PALISADES

CONSUMERS ENERGY RESPONSE TO TECHNICAL
MEETING W/NRC ON FEBRUARY 26, 1997

**CONSUMERS ENERGY COMPANY
PALISADES PLANT
DOCKET 50-255**

**Consumers Energy Response
to Technical
meeting with NRC on
February 26, 1997**

Figure 1-1

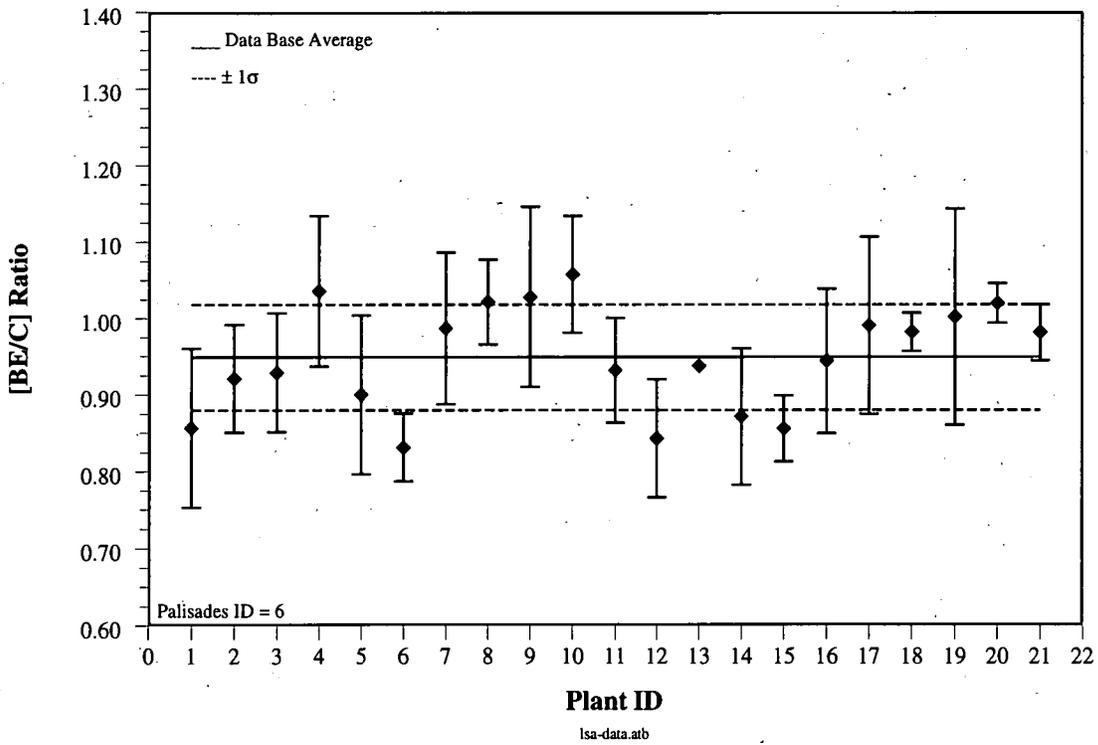
NRC Issue 1: *Why are the plant specific bias factors so different?*

The evaluation of these dosimetry sets and subsequent comparison with calculation indicates that, on average, the analytically predicted fluence exceeds the best estimate value by approximately 5%. The data base average $[BE]/[C]$ bias factor is 0.95 with an associated standard deviation of 7%. The plant specific average $[BE]/[C]$ bias factors range from 0.83 to 1.06, thus, all of the observed biases fall within $\pm 12\%$ of the average value. Considering the entire set of 158 individual measurement points, all of the data fall within $\pm 25\%$ of the mean value of 0.95. It is expected that an individual plant will have errors in its calculational inputs that are isolated to that plant. An average $[BE]/[C]$ of 0.95 implies that in general the calculations are biased high. However this average value does not have any meaning for a specific plant since each plant will have its own bias that is a combination of both the generic methodological bias and the plant specific bias and these two biases cannot reasonably be separated. A summary of the $[BE]/[C]$ bias factors for the 21 reactors currently comprising the data base is provided in Table 1-1. These data are shown graphically in Figure 1-1.

Figure 3-1

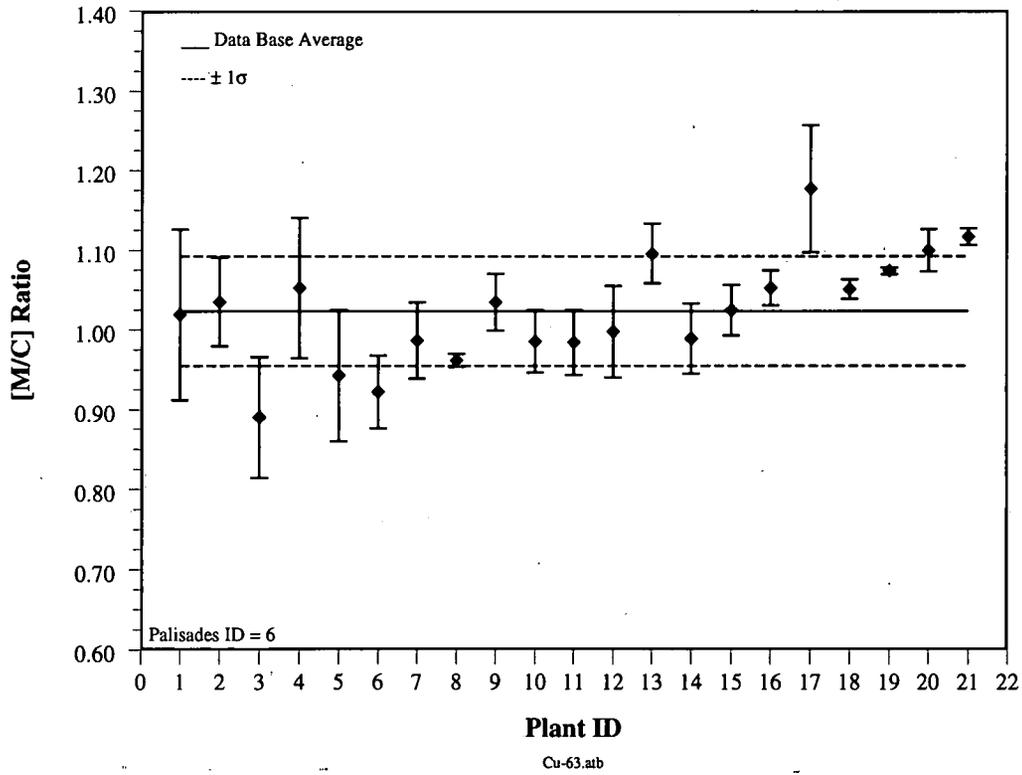
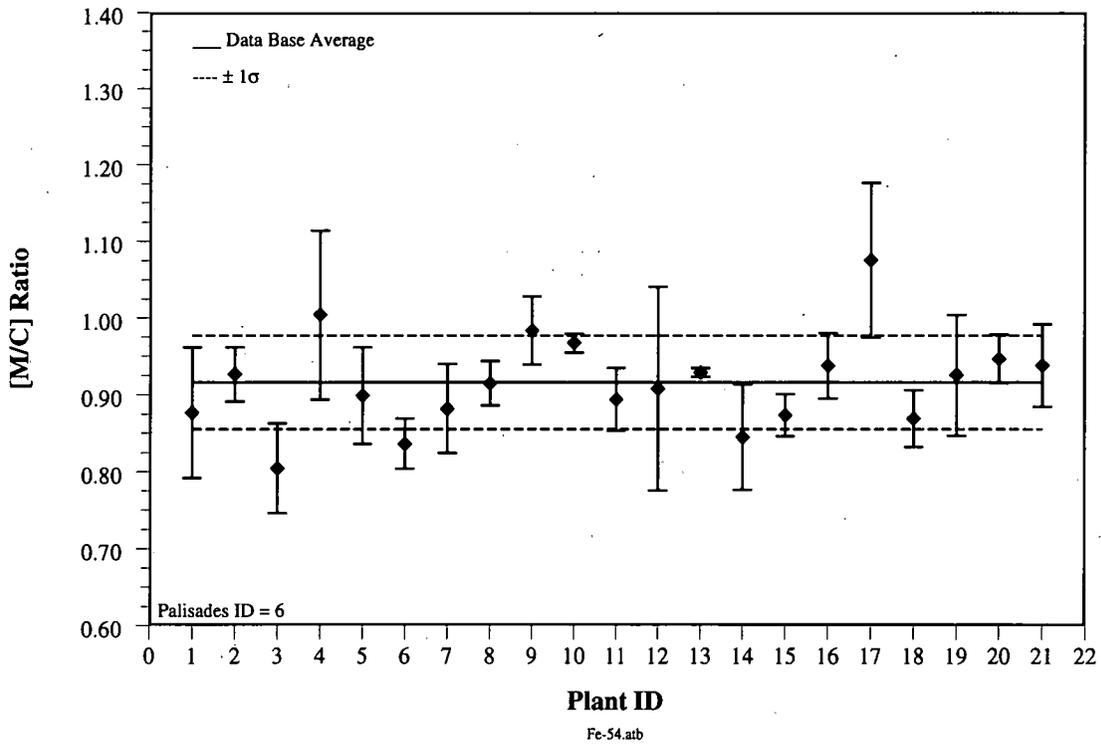
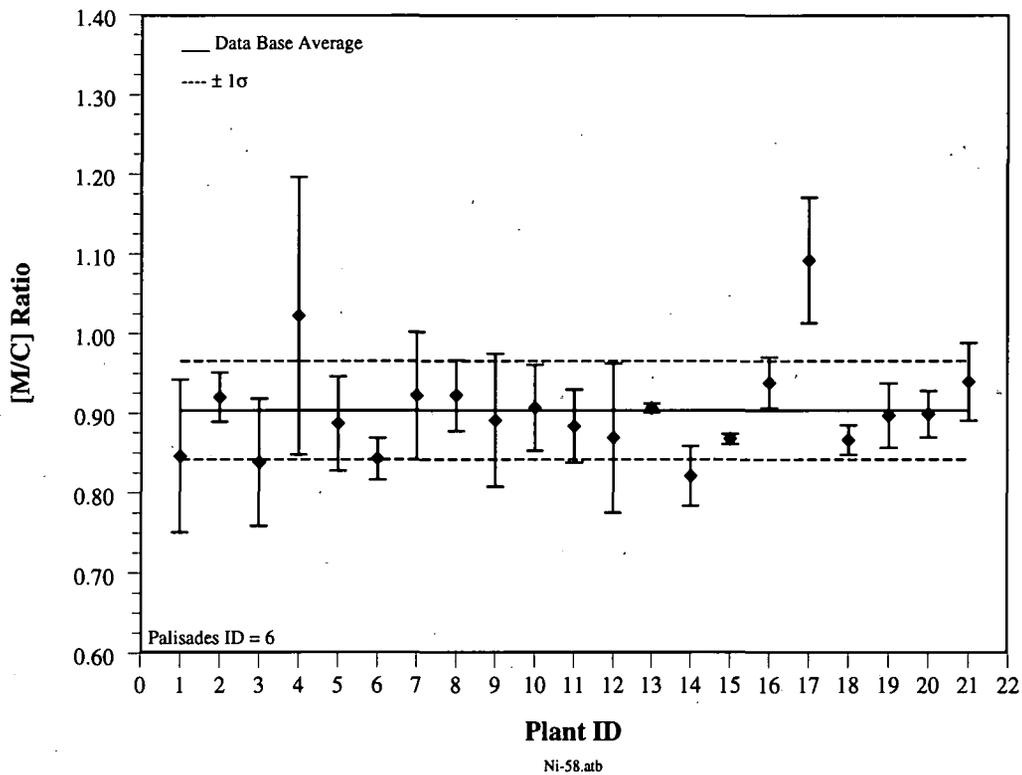
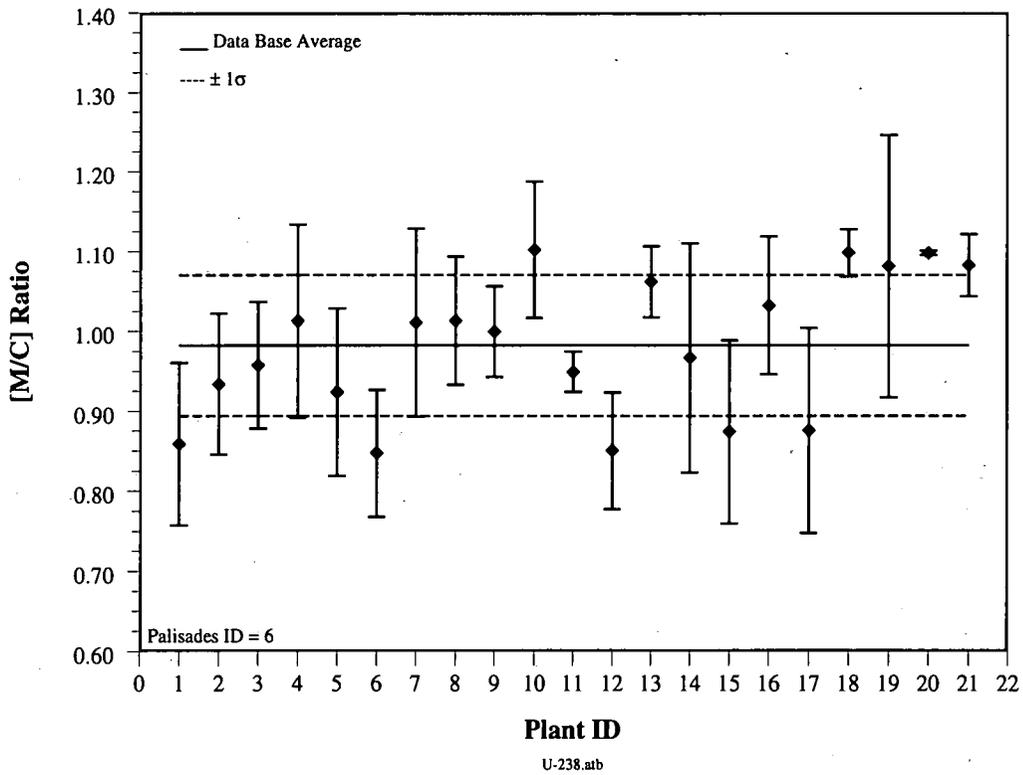
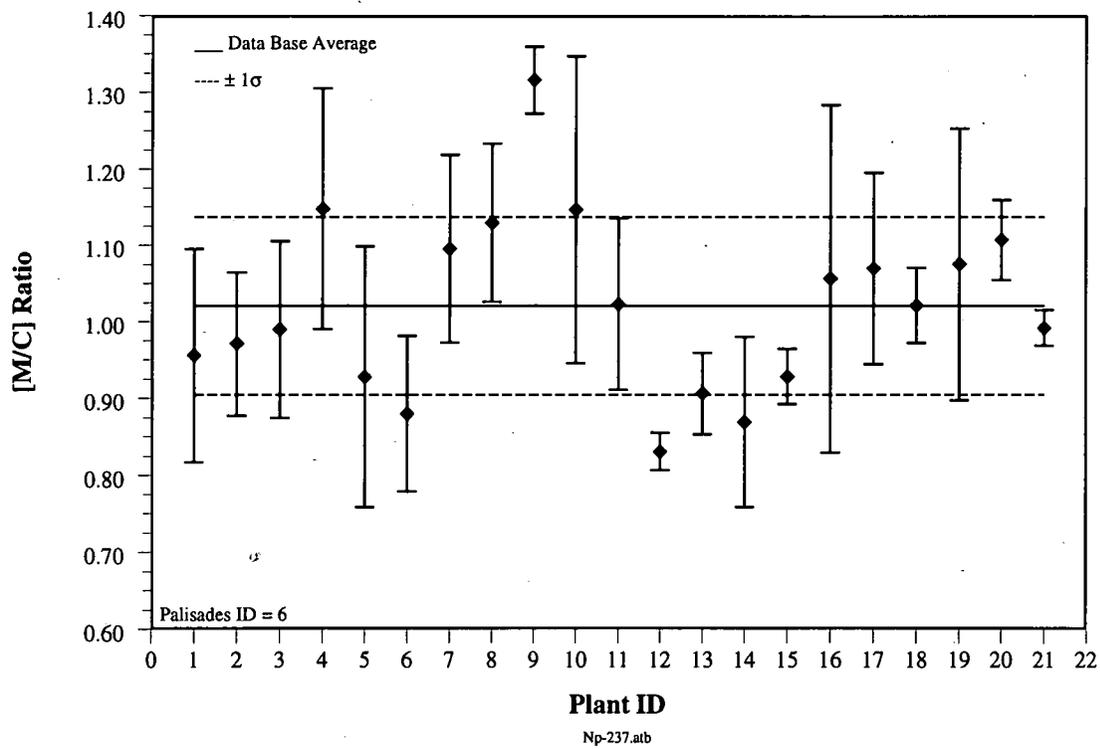
NRC Issue 3: *Why is the spread on Palisades M/C comparisons tighter than at other plants?*

More detailed summaries of the absolute [M]/[C] ratios for the individual sensors that comprise the multiple foil sets used in both in-vessel and ex-vessel irradiations are provided in Tables 3-2 through 3-7 for the ^{63}Cu (n, α), ^{46}Ti (n,p), ^{54}Fe (n,p), ^{58}Ni (n,p), ^{238}U (n,f), and ^{237}Np (n,f), reactions respectively. These data are illustrated graphically in Figures 3-1 through 3-5, except for ^{46}Ti (n,p) due to the limited data.
